# SUNNICA ENERGY FARM

EN010106

8.8 Applicant's Response to the First Written Questions

<b>Version</b>	<b>Date</b>	<b>Status of Version</b>
Rev 00	11 November 2022	Deadline 2 Version

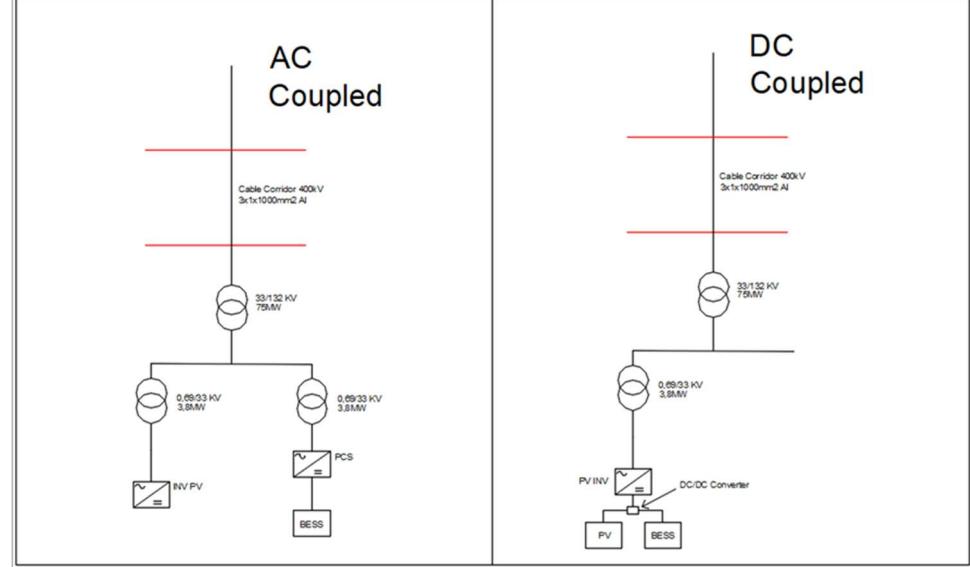
Q1.1.3	The Applicant	<p><b>Battery energy storage system (BESS):</b>            Table 3-2 (foot of page 8) and paragraph 3.4.2 g. of the Scheme Description [APP-035] state that there is a BESS in Works No 2A, 2B and 2C, but not 2D.            Why is this?</p>	<p>The Sunnica design utilises an AC-coupled BESS technology solution which is centralized (aggregated) and located close to the on-site substations (33/400kV transformer compounds) so that medium voltage (MV) losses are minimized. This is owing to the shorter distance that the cables need to travel. The longer the cable distance the greater the losses.</p> <p>There are 3 on-site substations within the areas shown on the Works Plan for works 3A, 3B and 3C and, because there is no on-site substation located at Sunnica West B neither is there BESS located on that site. There is no need for an on-site substation associated with the solar PV in Sunnica West B because it is more economic to connect the solar PV in this work area to the on-site substation located at work area 3C. While there will be elevated losses associated with the distance between the on-site substation and work area 2D the additional</p>

ExQ1	Respondent	Question	Applicant's Response
			cost of an on-site substation would be far greater than the value of the losses and not justify the additional cost impacts.
Q1.1.4	The Applicant	<p><b>Battery energy storage system (BESS):</b> By way of background</p> <ul style="list-style-type: none"> <li>• Paragraphs 3.4.23 to 3.4.32 of the Scheme Description [APP-035] give a brief description of the Battery Energy Storage System (BESS) but do not mention fire risk.</li> <li>• Fire is mentioned briefly in general terms in section 16.5 of ES Chapter 16: Other Environmental Topics [APP-048] (Major Accidents and Disasters) with brief references to ES Appendix 16D entitled “Unplanned Atmospheric Emissions from Battery Energy Storage Systems (BESS)” [APP-124].</li> <li>• Concerns about the fire risk of the batteries being installed are mentioned briefly in the penultimate entry in ES Table 16.8 [APP-048] which covers Section 47 response (statutory consultation): the response states that <i>“an Outline Fire Safety Management Plan has been prepared as part of the DCO submission [EN010106/APP/7.9].”</i></li> <li>• ES Appendix 16D entitled “Unplanned Atmospheric Emissions from Battery Energy Storage Systems (BESS)” [APP-124] and</li> </ul>	<p>The EIA process has included the consideration of fire risk to environment; ES Appendix 16D entitled “Unplanned Atmospheric Emissions from Battery Energy Storage Systems (BESS)” [APP-124] presents an assessment of an unplanned/emergency fire scenario on atmospheric emissions and human inhalation. The fire risk is not anticipated to generate a “likely significant effect”. This risk is discussed in the Outline Battery Fire Safety Management Plan [APP-267], which is not part of the ES.</p> <p>Table 16-8 of Chapter 16 of the ES [APP-048] states that emergency response is covered in the Framework CEMP (Appendix 16C of this Environmental Statement [EN010106/APP/6.2]), and notes that an Outline Fire Safety Management Plan has been prepared [EN010106/APP/7.9], and a BESS Air Quality Fire Risk Assessment has been prepared and is provided in Appendix 16D of the ES [EN010106/APP/6.2]. Paragraphs 16.5.15 and 16.5.23-16.5.39 of Chapter 16 of the ES provide a summary and assessment of these documents and appendices as part of the ES. The mention in Chapter 16: Other Environmental Topics [APP-048] to “an Outline Fire Safety Management Plan has been prepared as part of the DCO submission [EN010106/APP/7.9]” is an error. This should have read “an Outline Battery Fire Safety Management Plan [EN010106/APP/7.6]”. Chapter 16 has been amended and submitted as one of the Applicant’s Deadline 2 submissions.</p> <p>With regards to the documents made available to the councils, the PEI Report did not include an Outline Battery Fire Safety Management Plan. A draft Outline Fire Safety Management Plan was shared with Suffolk County Council outside of statutory consultation ahead of submission, with SCC taking a lead on safety matters on behalf of the host councils. A copy was shared with West Suffolk Council, who also asked to be involved. It is the Applicant’s understanding that CCC and East Cambs passed over responsibility to Suffolk County Council and their respective Fire Departments to provide comments on the draft Outline Battery Fire Safety Management Plan ahead of submission. The report was also copied to HSE but this did not constitute consultation.</p>

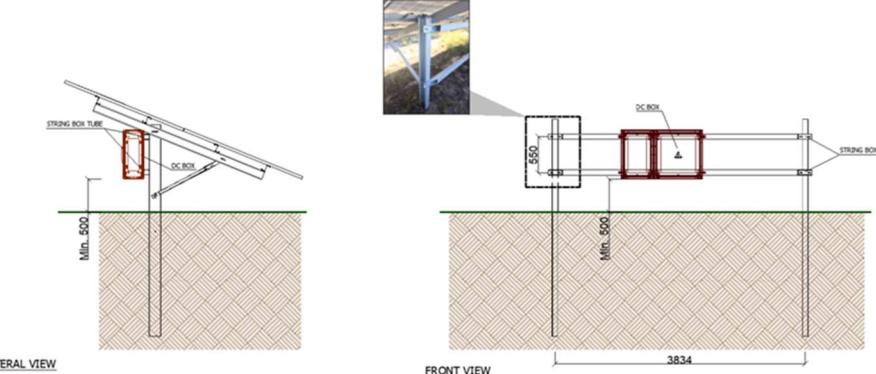
ExQ1	Respondent	Question	Applicant's Response
Q1.9.1	The Applicant	<p><b>Solar tracking systems</b></p> <p>Does the Applicant agree with the general proposition that solar tracking systems increase electricity production over fixed panel installations which latter cost less to install but require more panels to achieve a similar gain than tracking systems, thus requiring a larger land take. If not why not?</p> <p>Has the Applicant performed a cost benefit analysis that demonstrates the extra area of land that would be required for the Proposed Development over the use of a solar tracking system in order to produce the same amount of energy? If so please indicate where this is in the application documents.</p>	<p><b>Introduction</b></p> <p>The Applicant agrees with the first part of the general proposition set out in the ExA's question that tracking systems increase production but cost more. However, the Applicant disagrees with the second part of the general proposition set out that all tracking systems use less land when compared to fixed panel installations.</p> <p>The Applicant has a holistic approach to inform solar PV technology selection and design which considers the potential environmental and planning constraints alongside technical and economic considerations.</p> <p>The Applicant has considered the key environmental and planning constraints and the key technical and economic considerations below which has informed the decision to select a fixed panel design. A simple comparative analysis highlights why the fixed south-facing option was the preferred technology design choice.</p> <p><b>Environmental and Planning Constraints</b></p> <p>One of the primary environmental and planning constraints that informed the selection and design of solar PV technology for the Sunnica project was the height of the PV panels above ground level. The original design work undertaken pre-application was that the height of the PV arrays needed to be limited to 2.5m Above Ground Level (AGL) so as to limit the land landscape and visual impact.</p> <p>The Landscape and Visual Impact Assessment, the results of which are presented in Chapter 10 of the Environmental Statement [APP-042], has informed the design of the Scheme from the earliest stage. This included consideration of east-west PV array orientation and PV arrays of greater height. The landscape within the site is generally flat or gently undulating and taller panels were found to increase the extent of visibility. This is because they would extend above the height of hedgerows, which are important boundary features across much of the area. This principle meant that tracking panels which were 2V</p>

ExQ1	Respondent	Question	Applicant's Response
			<p>in portrait had to be discounted as they would exceed the maximum height of 2.5 AGL. This is explained in more detail below.</p> <p>The view from the Limekilns Gallops was given particular consideration because the elevated, open aspect gives rise to more extensive views across the landscape. In this view, tracking panels would be more conspicuous due to their height, but also the movement as they track the sun across the sky. This would expose more of the framework of the panels towards the viewpoint in the morning and late afternoon, drawing attention to them, rather than the continuous appearance of the face of panels receding into the background in the south-facing, fixed orientation proposed.</p> <p><b>Technical and economic considerations</b></p> <p>Solar PV panel design is determined in part by a series of technical and economic considerations. The following technical considerations are the most relevant to understanding the design choices made at the Sunnica scheme.</p> <p><u>Technical considerations</u></p> <p>The two key technical considerations are the panel height and the row pitch.</p> <p>The maximum panel height is set out in Chapter 3 of the Environmental Statement [<b>AS-299</b>]. This constraint is one of the key limiting factors in determining potential panel selection and configuration for the Sunnica scheme. Within these constraints the panels would be arranged in portrait format and either as single panels (1V) or as two in portrait (2V). This constraint limits the assessment to:</p> <ul style="list-style-type: none"><li>• 2V 550 W south-facing fixed – 2.5m</li><li>• 1V 550W E-W tracker – 2.5m</li></ul> <p>The row pitch is the spacing between the rows of panels fixed onto the racking that supports them. The spacing of the rows impacts energy yield in terms of:</p> <ul style="list-style-type: none"><li>• Specific yield (kWh/ kWp/year)</li></ul>

ExQ1	Respondent	Question	Applicant's Response
			<ul style="list-style-type: none"><li>• Energy output per hectare (MWh/ha)</li><li>• Capacity per hectare (MWp/ha)</li></ul> <p>The row pitches that have been considered in this analysis are the following:</p> <ul style="list-style-type: none"><li>• 2V 550 W south-facing fixed - pitch 6.8m</li><li>• 1V 550W E-W tracker – pitch 4.5m</li></ul> <p>In order to maximize the installed peak power (for energy production) within the minimum area, pitches have been selected which have the minimum clearance required between rows for maintenance purpose (such as for cleaning modules or conducting other maintenance).</p> <p><b>Economic considerations</b></p> <p>An economic analysis needs to assess the capital expenditure and the operational expenditure and compare the differences between them for a fixed system versus a tracker system.</p> <p><b>Capital expenditure</b></p> <p>The capital expenditure of a scheme is determined by the up-front costs of construction and installation. The key difference between the two systems relates to the increased cost of the tracking system over the fixed system. The cost relates to the amount of metal involved with the deeper foundations and substructure, the motors, tracking system, safety equipment, software and hardware (electronics) required and the additional construction costs.</p> <p>The extra system cost estimated for change from fixed 2 modules on portrait solution to tracker 1 module portrait is around 50% more which is equivalent to an uplift of £40,000 per MWp.</p> <p><b>Operational expenditure</b></p>

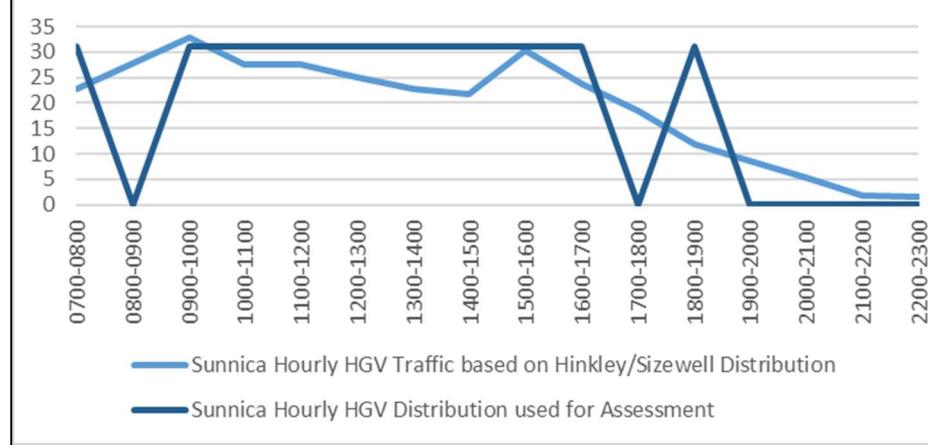
Q1.10.96	The relevant highway authority	Question not for Applicant.	
Q1.10.97	The Applicant	<p><b>Assessment methodology</b></p> <p>In paragraph 13.4.14 of the Transport and Access chapter of the ES [APP-045] you</p>	The October 2019 IEMA Impact Assessment Strategy does not provide an update on the IEMA guidelines for Transport and Access assessments. Therefore, it has

ExQ1	Respondent	Question	Applicant's Response
		<p>say that your methodology has been based on the 1994 Guidelines for the Environmental Assessment of Road Traffic (GEART) from the Institute of Environmental Assessment (IEMA).</p> <p>Has the 2019 IEMA Impact Assessment Strategy resulted in any material changes to the GEART criteria or the way in which the impacts of road traffic are assessed?</p>	not resulted in any material changes to the GEART criteria or the way in which the impacts of road traffic are assessed
Q1.10.98	The relevant local planning and highway authorities	Question not for Applicant.	
Q1.10.99	The Applicant	<p><b>Assessment: new traffic data</b></p> <p>Paragraph 13.3.1 of the Transport and Access chapter of the ES [APP-045] highlights the limitations and the assumptions made in respect of the assessment.</p> <p>Since the easing of public health restrictions in March of this year, have you collected any new traffic data to assess whether traffic flows are returning to normal and to assist in filling gaps in the data available to you prior to submitting this application?</p> <p>If so, how does the new information inform your assessment of the impacts and consequential effects of construction traffic and the consequential need for mitigation, particularly in tranquil locations?</p> <p>If not, do you have any proposals to gather new and more up to date information to help you to assess the impacts and</p>	<p>The potential to undertake additional traffic surveys to provide further confidence in the conclusions in the ES was discussed with the Local Highway Authorities and is set out in detail in Section 4 of the Transportation Technical Note [EN010106/APP/8.42]. It was agreed between the Applicant and the Local Highway Authorities that there are areas where additional data would increase the level of confidence in the conclusions through providing a more comprehensive geographical coverage of data. These locations are as follows:</p> <ul style="list-style-type: none"> <li>• La Hogue Road;</li> <li>• Elms Road (to the west of the A11 Northbound Off-Slip T-Junction);</li> <li>• Freckenham Road; and</li> <li>• A142 and Burwell.</li> </ul> <p>The Local Highway Authorities were unable to provide any additional data. Additional traffic surveys were therefore carried out from Thursday 7<sup>th</sup> to Wednesday 13<sup>th</sup> July 2022, with the LHAs provided with an opportunity to comment on the survey scope (no comments were received). The traffic surveys included Elms Road, the A11/Elms Road T-Junction, La Hogue Road and Freckenham Road. It was agreed with the Local Highway Authorities that there was no additional data requirement for the A142 and Burwell, given low number</p>

ExQ1	Respondent	Question	Applicant's Response
		mitigate the effects of construction traffic more accurately?	<p>of staff and HGVs, and therefore there was no need to undertake additional surveys to provide additional confidence in the assessment conclusions.</p> <p>The analysis applied within Chapter 13 – Transport and Access of the Environmental Statement [APP-045] has been updated using the July 2022 survey data. This includes severance, driver delay and fear and intimidation. The results of the updated analysis indicate that in the AM and PM development peak hours the links in question are forecast to have either a negligible or minor adverse impact in terms of severance, pedestrian delay, pedestrian / cycle amenity and fear and intimidation. This is not considered to be significant in EIA terms.</p>
Q1.10.100	The Applicant	<p><b>Assessment: professional judgement</b></p> <p>In paragraphs 13.3.2 and 13.4.5 of the Transport and Access chapter of the ES [APP-045] you say that in the absence of baseline traffic data professional judgement has been applied to form a conclusion.</p> <p>Please give examples of instances where you have done this.</p> <p>What evidence do you have that baseline flows are returning to normal following the lifting of public health restrictions?</p> <p>Would the availability of new data now that the public health restrictions have been lifted be a useful validation of your professional judgement?</p> <p>In line 4, to which paragraph are you referring in respect of the assessment of links where the traffic flows are predicted to increase by more than 30%?</p> <p>If traffic flows do not return to normal, would there be additional links requiring assessment?</p>	<p>In Chapter 13 – Transport and Access of the Environmental Statement [APP-045], professional judgement was applied for the assessment of locations where there were acknowledged limitations in the coverage of baseline traffic data available at the time the report was produced, and traffic surveys could not be carried out due to the impact of Covid restrictions on traffic flows. These locations included Elms Road, the A11/Elms Road T-Junction, La Hogue Road and Freckenham Road.</p> <p>As discussed in the response for Q.1.10.99, since the production of the Transport Assessment [APP-117], traffic surveys were undertaken in July 2022 at the locations where availability of new data would be a useful validation of the conclusions drawn.</p> <p>The analysis undertaken within Chapter 13 – Transport and Access of the Environmental Statement [APP-045] has been refreshed utilising the July 2022 survey data. The results of the analysis indicate that in the AM and PM development peak hours there will be no significant effects in terms of severance, pedestrian delay, pedestrian / cycle amenity and fear and intimidation. Therefore, it is considered that the conclusions of the Transport and Access chapter remain valid. Further details on the additional traffic surveys and the analysis are provided in Section 4 of the Transportation Technical Note [EN010106/APP/8.42].</p> <p>Discussion on whether baseline flows are returning to normal is set out in Q1.10.67. This states that traffic data has been obtained from WebTRIS for locations which have both 2019 and 2022 data available to determine if traffic flows have returned to pre-Covid levels. Traffic data for 2022 was only available</p>
